JUSTIFICATION

107 HIGH STREET, LINDFIELD, HAYWARDS HEATH, RH16 2HR

2. Proposed first floor plan

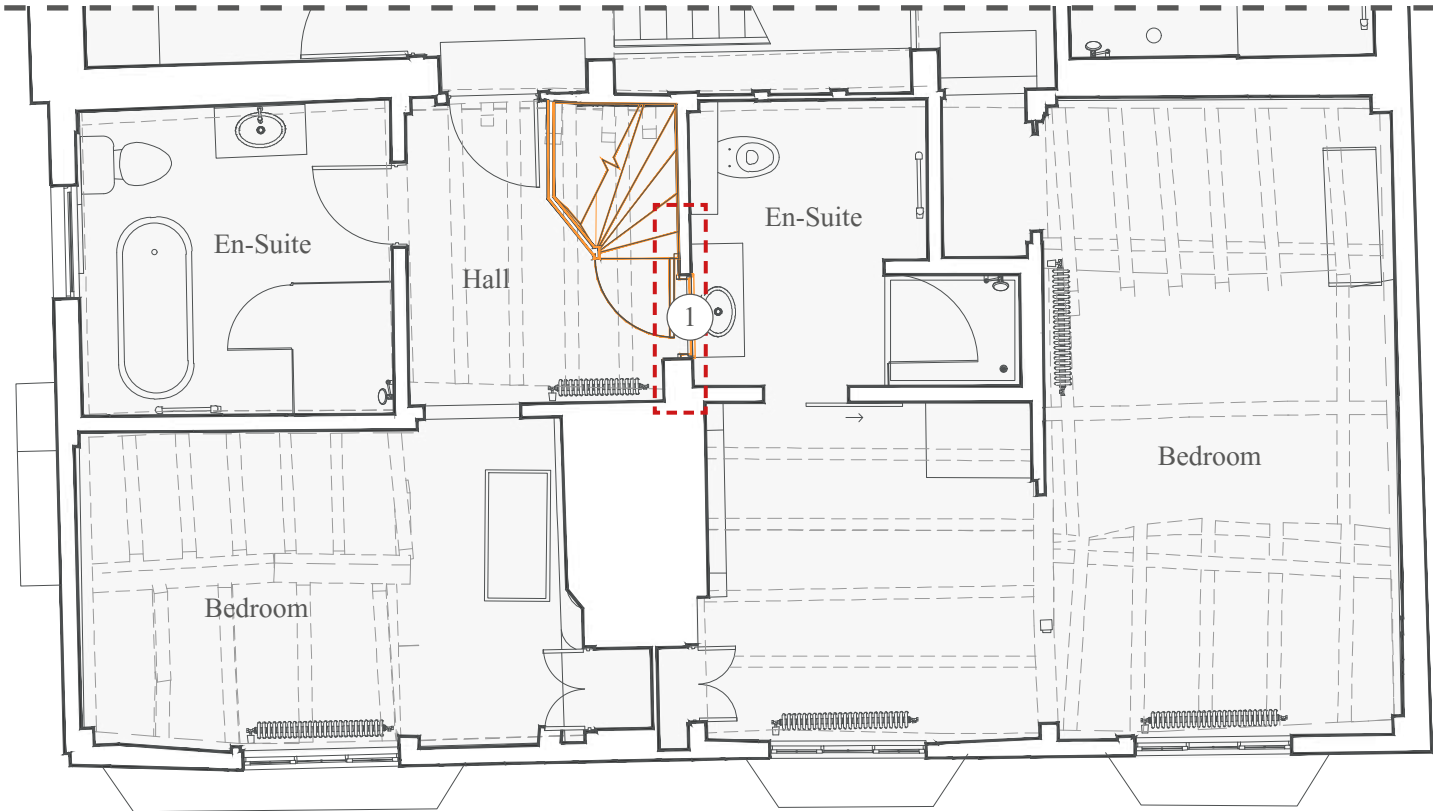
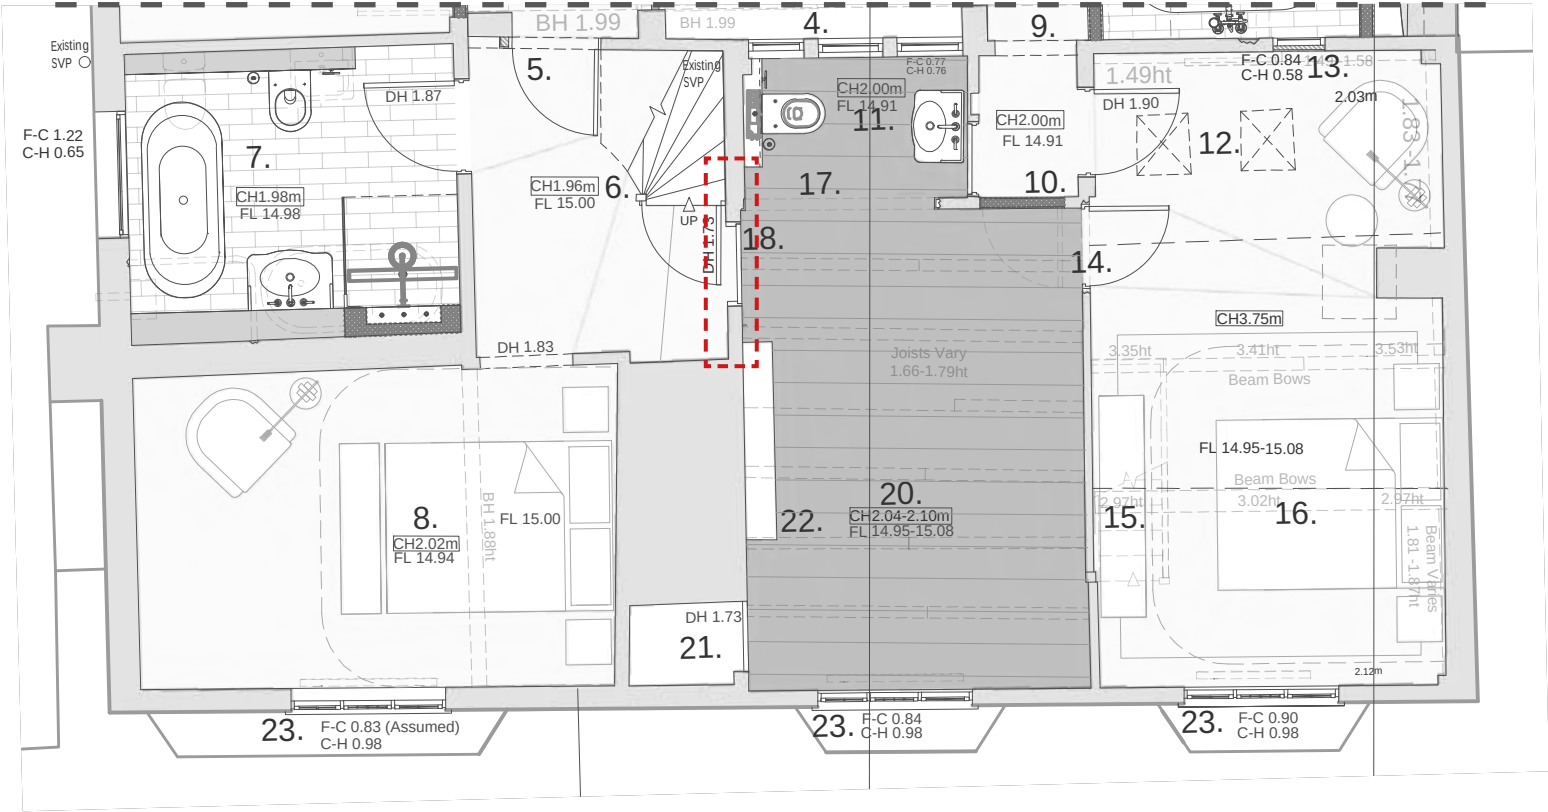
On the first floor, an existing opening in the internal wall was blocked up. It is proposed for the opening to be reinstated and door to be reinstated, but fixed shut.

Proposed roof plan

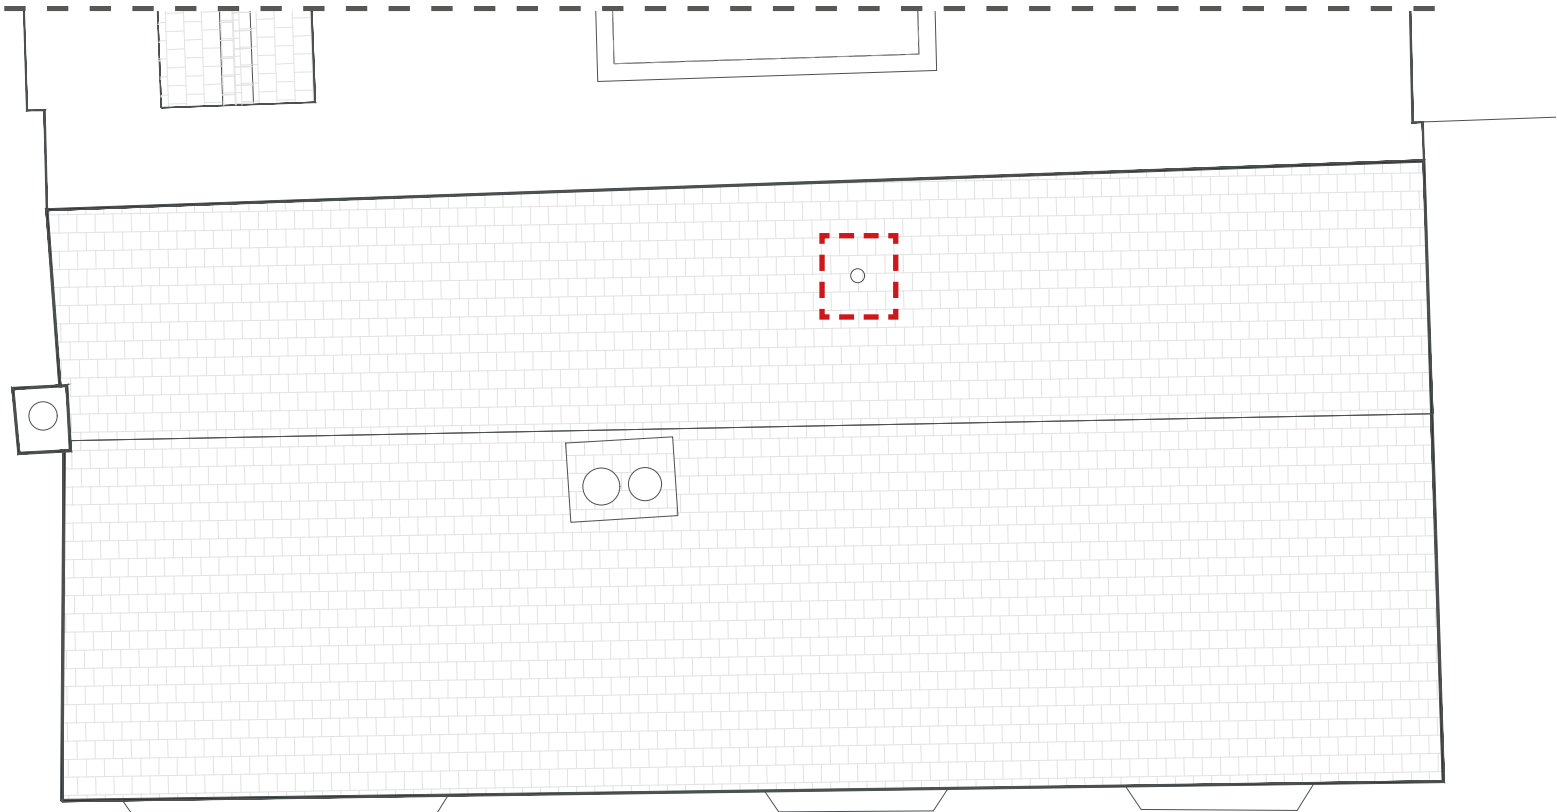
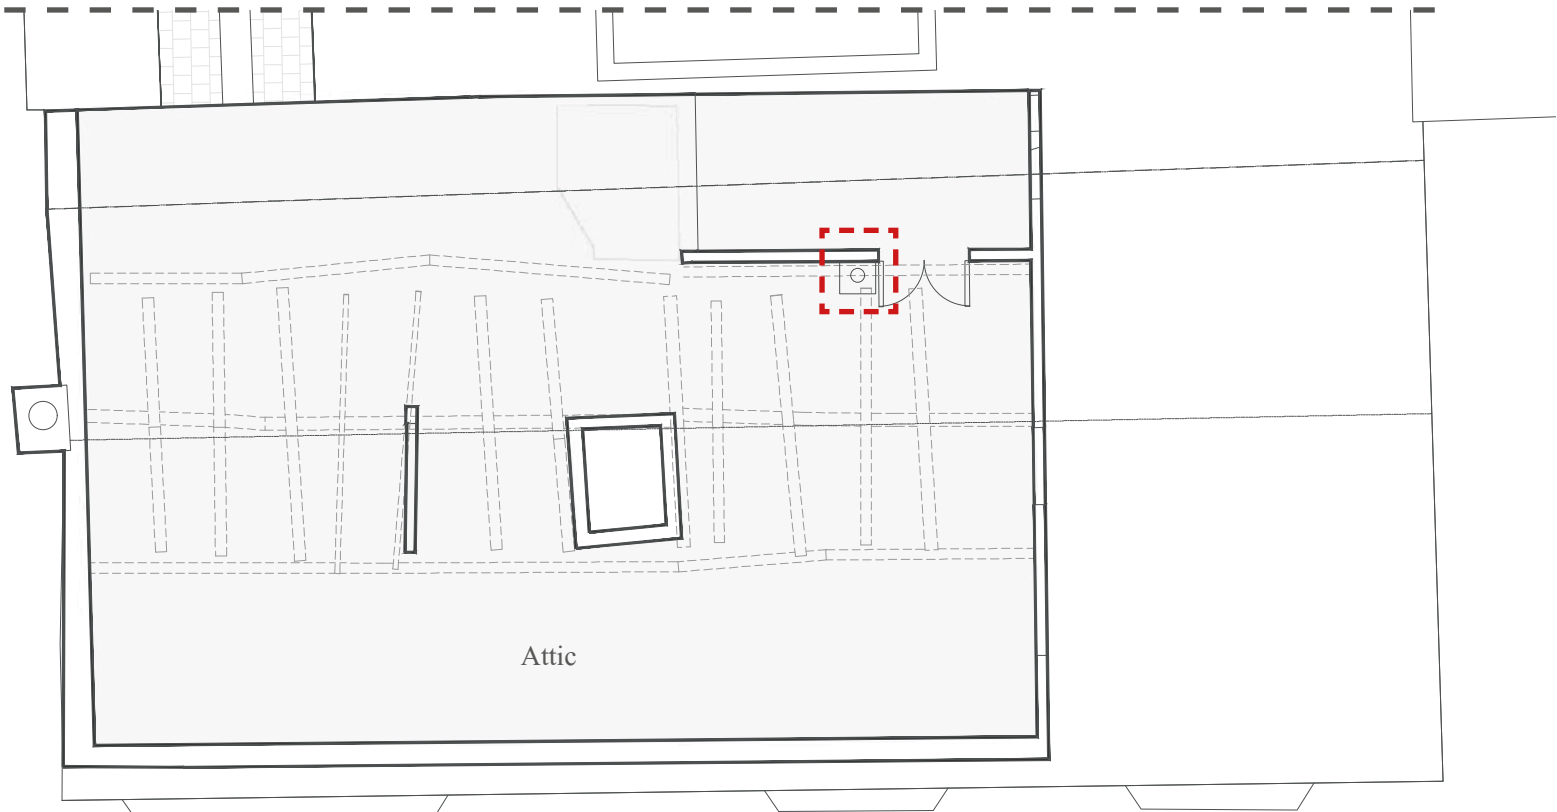
A new boiler flue has been installed on the second floor and protrudes through the roof. It was constructed without planning permission and is a part of retrospective works applied for under this application.

The flue is a 100mm diameter pipe penetration through roof with flashing around for waterproofing. It projects up circa 300mm from the face of the roof tiles but not above the main ridge line and is not visible from the front elevation.

3. Proposed rear elevation

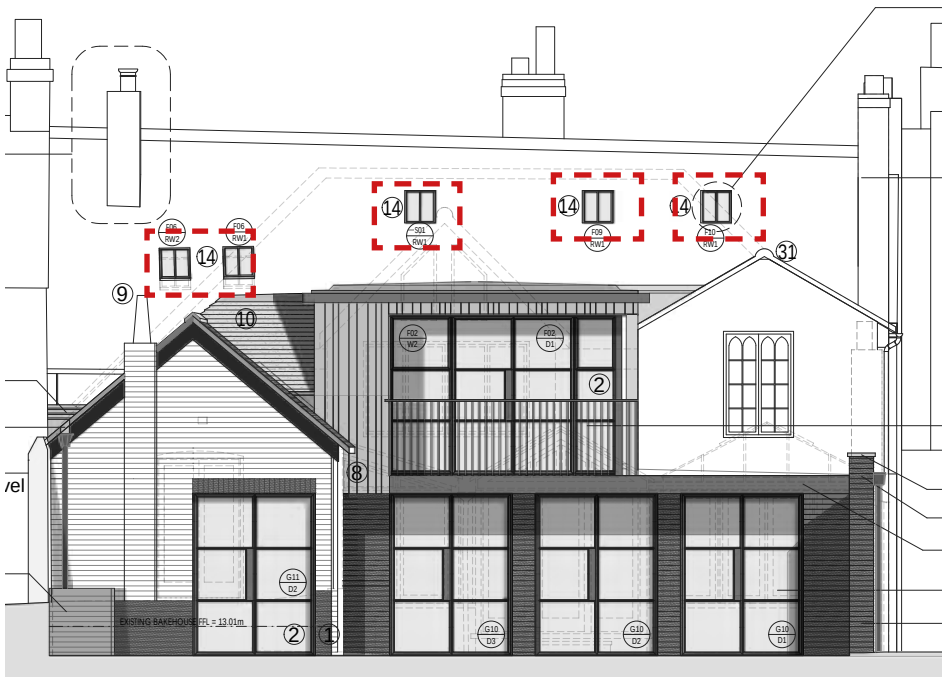
The removal of existing rooflights and under-implementation of approved rooflights to the west facing roof of the listed building is a positive change, restoring and maintaining the integrity or the rear roof slope . The adjacent roofs of neighbouring listed buildings are unencumbered by rooflights which is a highly positive attribute of the listed building’s setting within the wider conservation area. This change is considered a heritage benefit as outlined in the supporting HCUK heritage statement

Proposed Ground Floor Plan

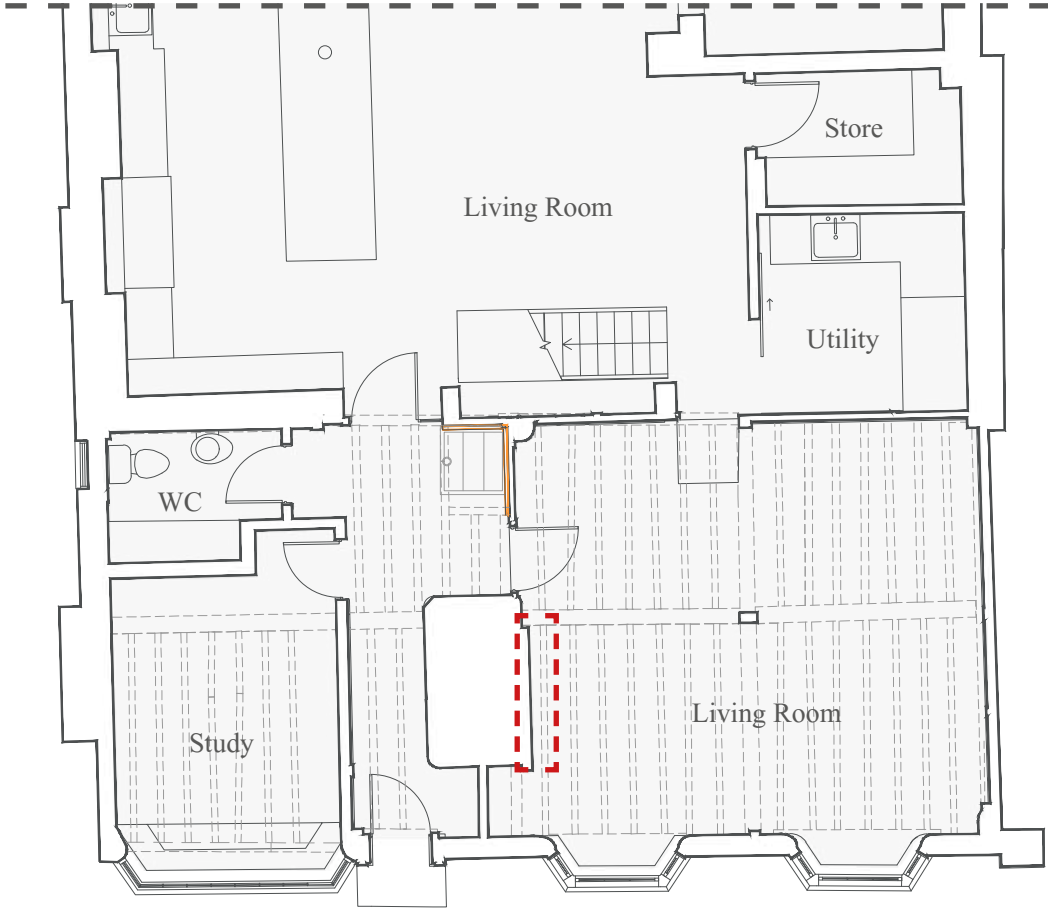
The condition of the ground floor main chimney breast has been significantly improved. The chimney breast has been re-faced in reclaimed brick using hydraulic lime mortar, with a new hearth being incorporated. This is considered an improvement to the listed house and a heritage benefit as outlined in the supporting HCUK heritage statement.

1. Existing blockwork removed from behind the existing hearth
2. Reclaimed brickwork cleaned where required across full extent of chimney prior to any repair works.
3. Any serious erosion from spalled brickwork to removed, then cleaned out and infilled with new brickwork and mortar mix with colour, texture and pointing to match existing.
4. Chipped or cement coated bricks removed, cleaned out and infilled with new brickwork and mortar mix with colour, texture and pointing to match existing.
5. Any open mortar joints, if not found to be a consequence of structural defects, cleaned out and infilled with new mortar mix with colour, texture and pointing to match existing.
6. New hearth incorporated

1. Approved ground floor plan - submitted drawings under application DM/22/3694 & DM/22/3695 (planning approved)

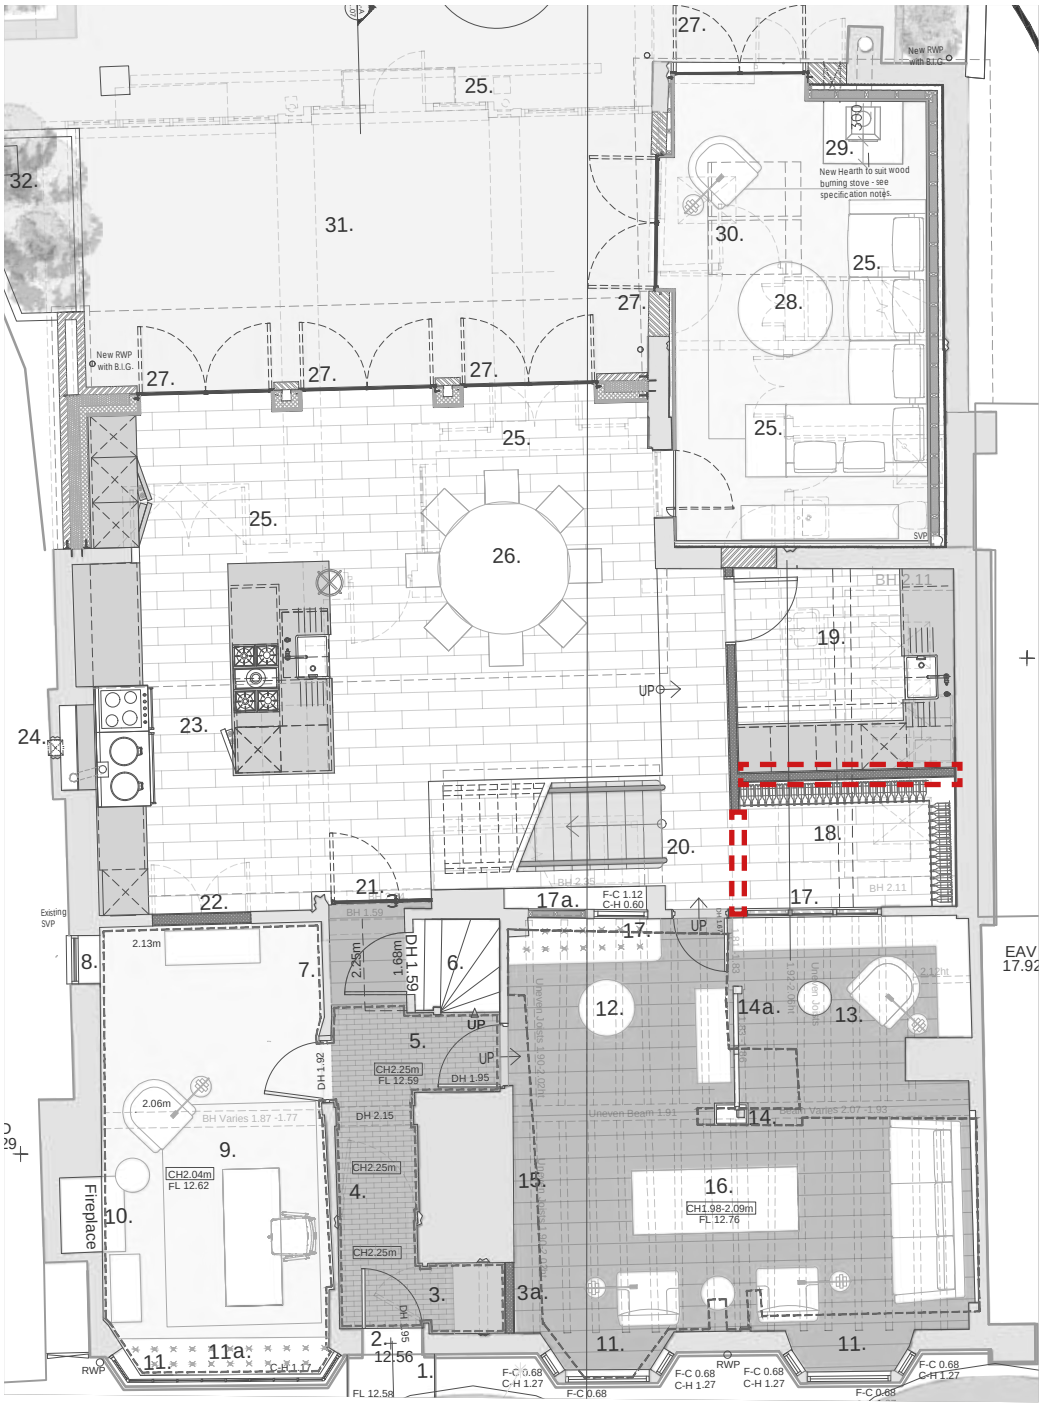
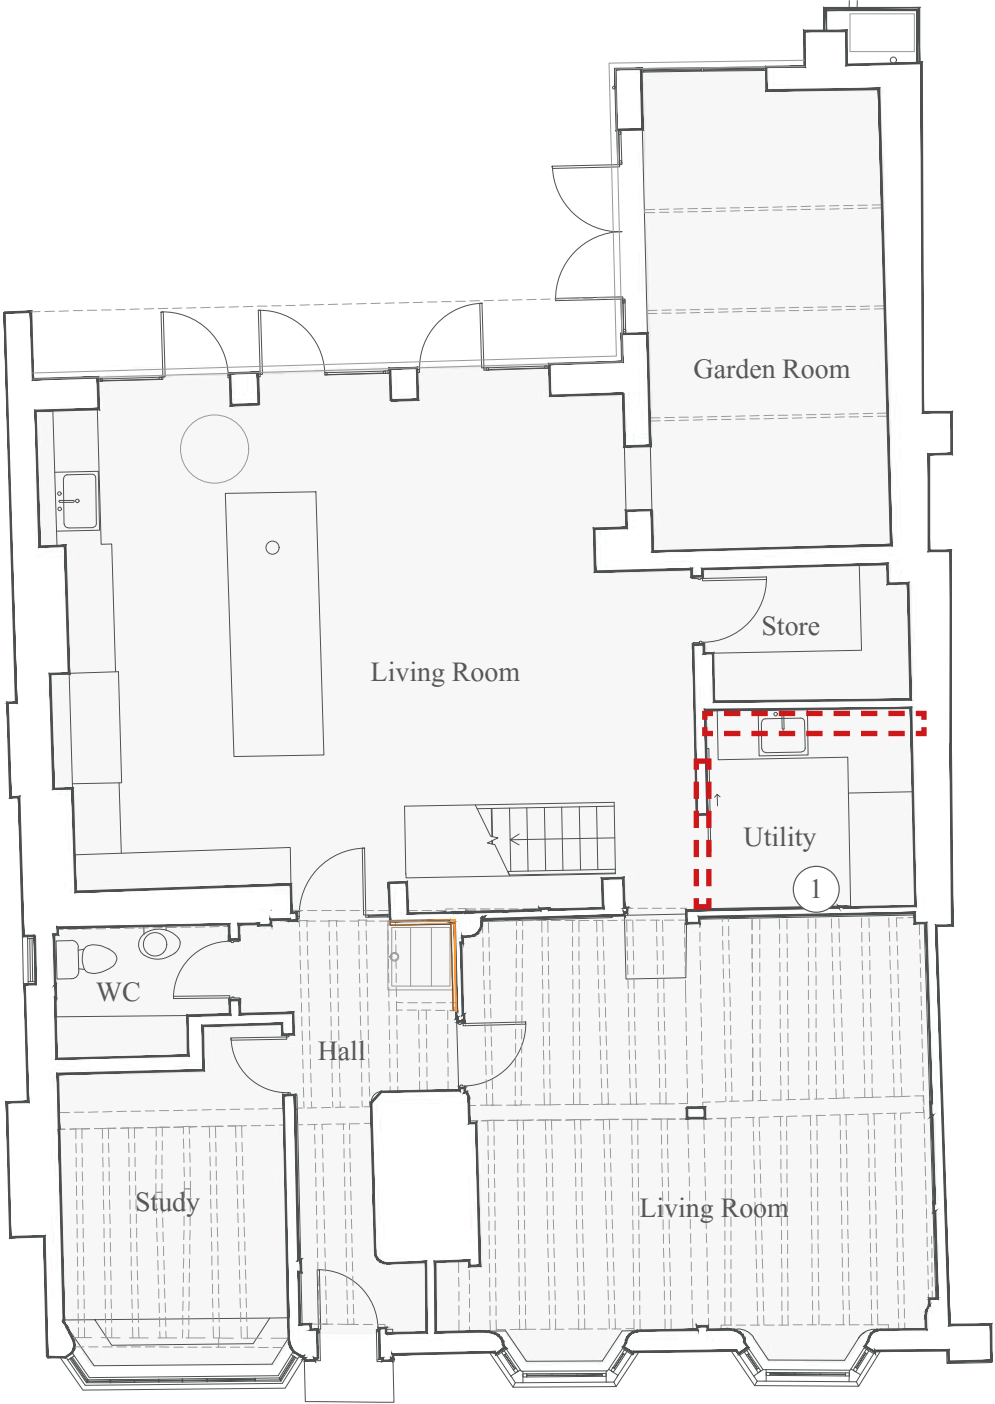
The ground floor utility and store were constructed with the following deviation from the approved scheme:

- Partition wall location shifted, enlarged utility at the cost of store space
- Addition of discreet sliding doors, bespoke door made of overlaid floor finish used on 1st floor, with door being hung on sliding door gear fabricated by local blacksmith.

This is a minor deviation from the approved scheme and is considered to have neutral effect on the listed building significance in accordance with the supporting HCUK heritage statement.

Proposed ground floor plan

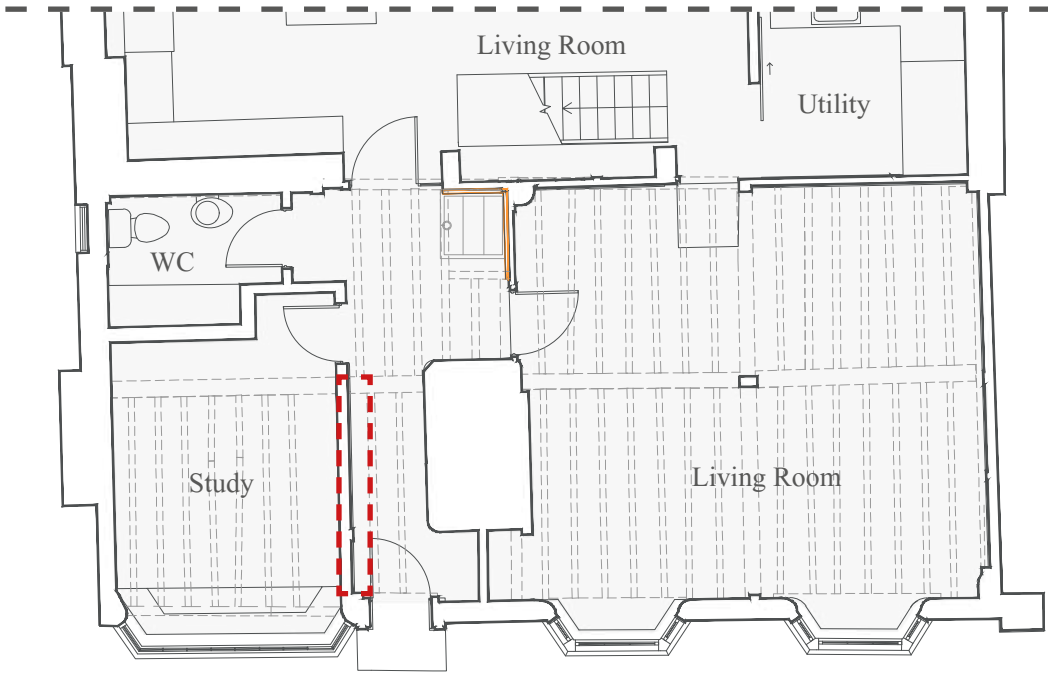
Existing timber framing to the southern wall in the entrance passage has been further exposed and carefully renovated during the engagement of heritage carpenter Nick Cain of Cruck Frame Carpentry. This sympathetic change reinforces the historic character of the main part of the house, which has been carefully restored. It is considered to have a neutral impact on the listed building's special interest, resulting in no harm in accordance with the supporting HCUK heritage statement.
